September 18, 2012

Alpensee Water District  
Director Mr. Don Skotty  
PO Box 2204  
Frisco, CO 80443

## INITIAL REPORT FINDINGS

FIGURE 1

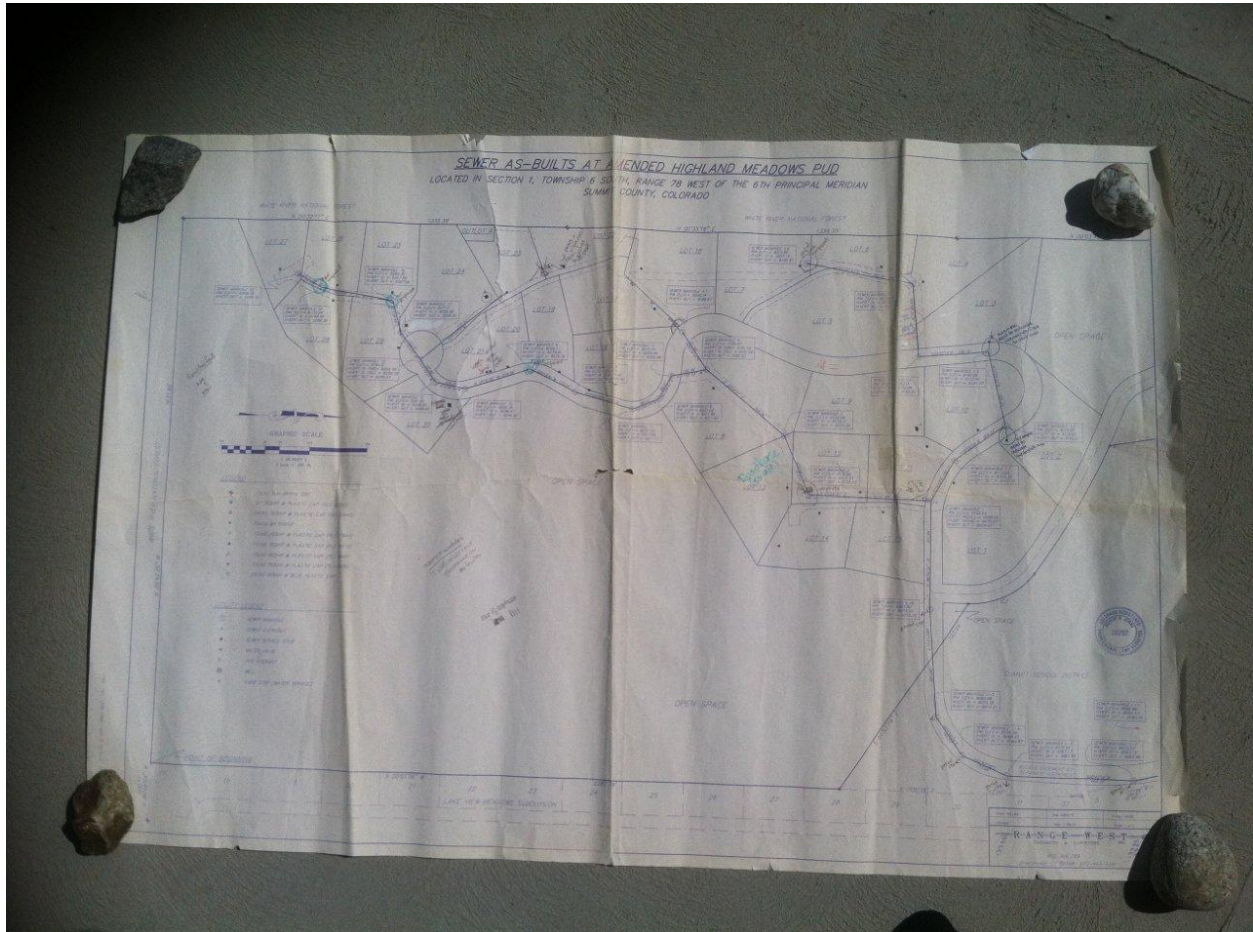
1. Sort the drawings into two piles:
  - A. AWD system drawings. So far I have found no Process and Instrument (P&ID) drawing certified or signed to indicate an as built state. Out-lot A is lot in Highland Meadows which is given easement from lots 22 and 23 for the purpose of water storage and distribution for the AWD. But this lot is not owned or maintained by the AWD. In the most recent AWD meeting, September 17, 2012, the public was told that Lot A belongs to the former Developer and AWD Board member Larry Smith and other Smith family members. But lot A was not on the list of customers of AWD, though Lot A receives fire mitigation from AWD. Lot A was surveyed and photographed. Elevations were also taken. This work was done to provide data to see if Lot A could be used in Lot A's original intent or some other support capacity. Please find **Figure 1; As built for 2 of 2 sewer HM draw**, the only "As Built" PUD distribution drawing found so far.

FIGURE 2

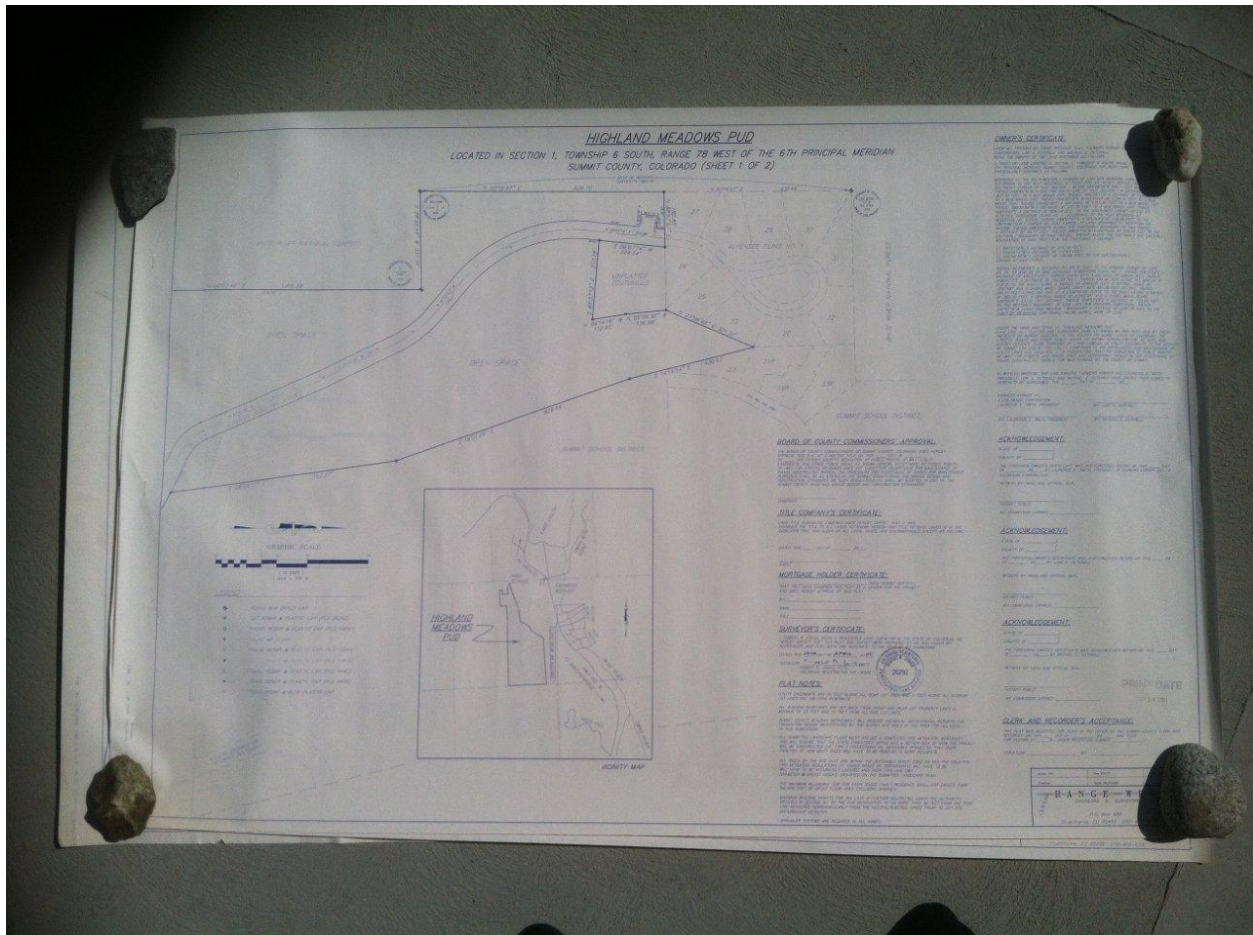
2. Looked for drawing to determine what is in Highland Meadows PUD. **Figure 2, HM PUD 1 of 2 for 14 lots W of HS** shows 14 more lots in the original Highland Meadows PUD submission for AWD.

FIGURE 9

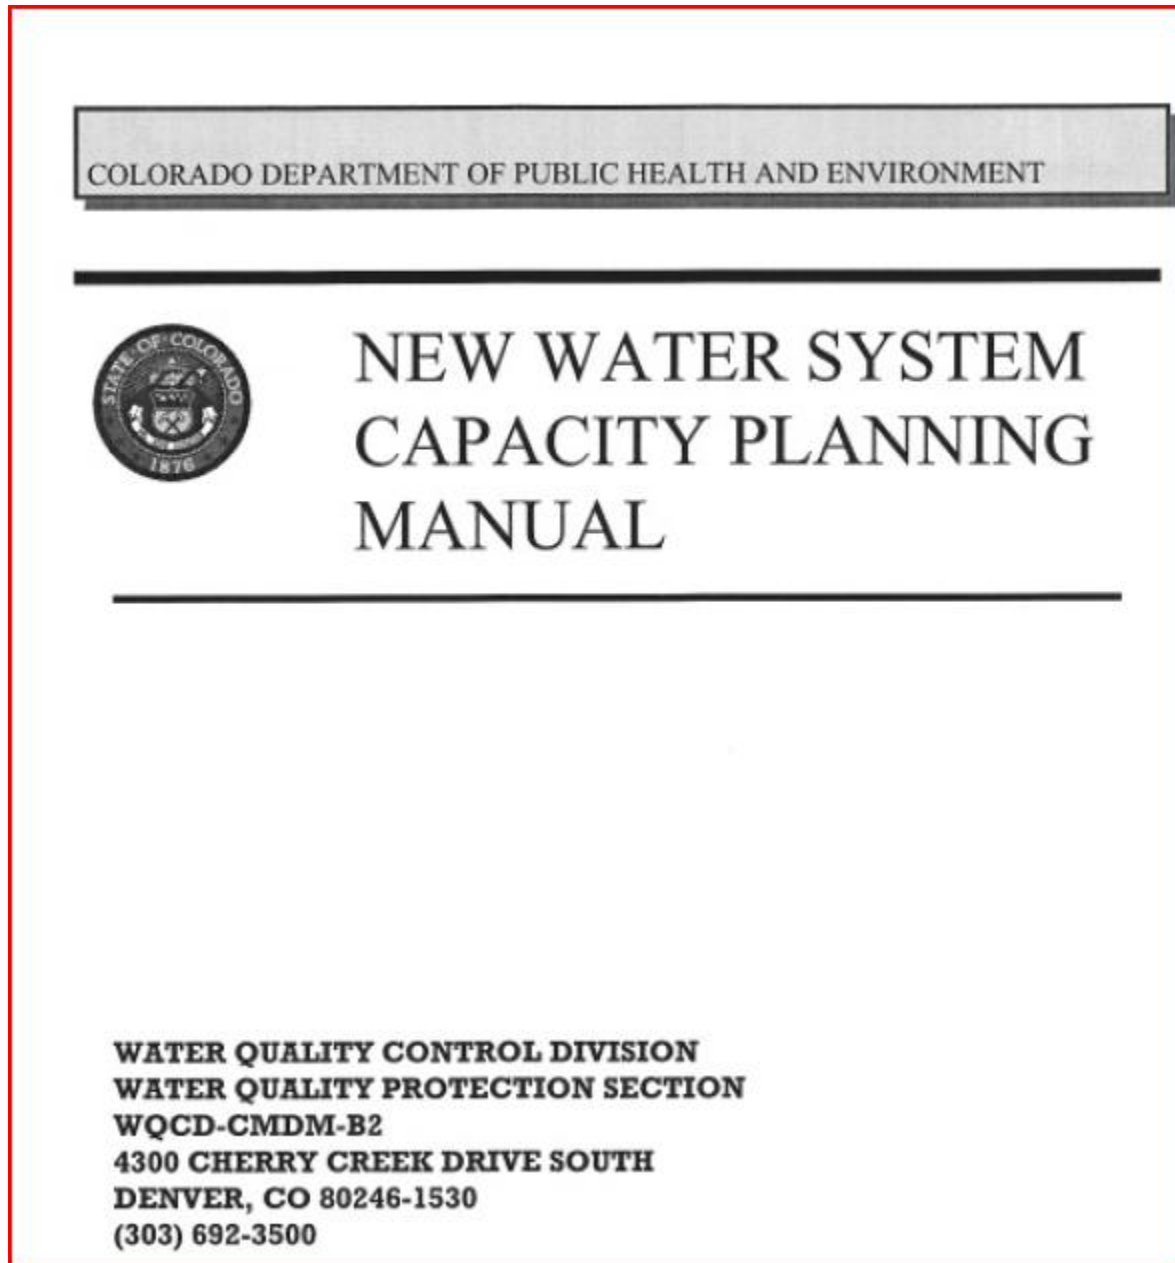
10. A copy of the New Water System Capacity Planning Manual is in the file. This document is more than 60 pages. The cover page, County Health Contact, and Approval Flow chart are in **Figure 9, Cover of Capacity Plan Manual no date.** The manual says you can get a copy of the Design Criteria for a potable water system by calling 303-692-3500. The manual has no revision date. However, forms in the manual are dated 12/97. A copy of the design Criteria for Potable Water Systems is in the file, dated March 1997. The Design Criteria costs \$5 USD and has more than 100 pages. I recommend someone from AWD call and see if the Design Criteria has changed and get copy of the updated Design Criteria if available. There are regulations as to what labs can be used and they are found in Article 1.2.3(8). I assume this the Colorado Code. These documents will get scanned when time is available.
